Chiarimenti (Clarifications)

Lista (List) #5

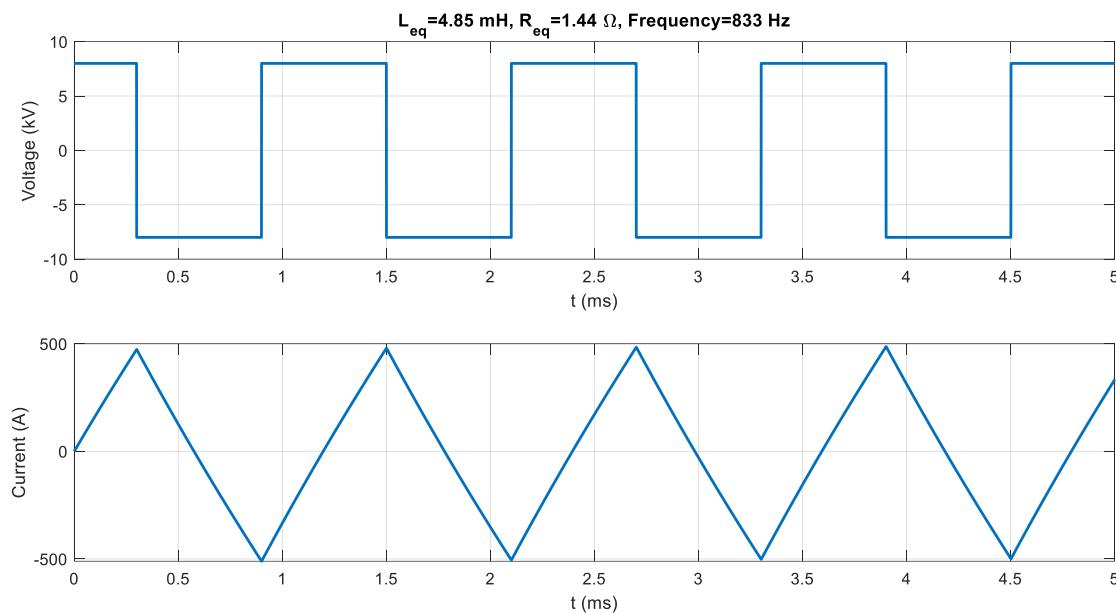
According to our preliminary simulations, it seems that +/-2x4kV maximum output voltage is not sufficient for correctly following the triangular current references on the spec. For example: Triangular waveform 4 (500Apeak, 833Hz) -> The load values of L and R are (in worst case, simplifying to only fundamental frequency, from fig.3): $L=4.85\text{mH}$, $R=1440\text{m}\Omega$.

Similar lack of voltage is found for the 3 other waveforms.

It is actually not immediate, but the behavior of a rectangular waveform is different with respect to sinewave.

You can simulate a circuit with a voltage source with rectangular wave on a load with the L and R for the corresponding frequency.

The numerical values at 833 Hz are slightly different, but this is not relevant. Your values are used in the following.

The result is shown in the plots below.

Be careful that, as reported in Section 4.3, “the waveforms achievable in the circuit will be not exactly triangular but the first part of exponential charges” and this may lead to a transient behavior. This effect is more evident at low frequency.

The rectangular waves shall be obtained in short circuit.

We expect that the actual equivalent R and L will be better than those shown in Figure 3. In any case, the effect of the load will be considered in the acceptance tests.
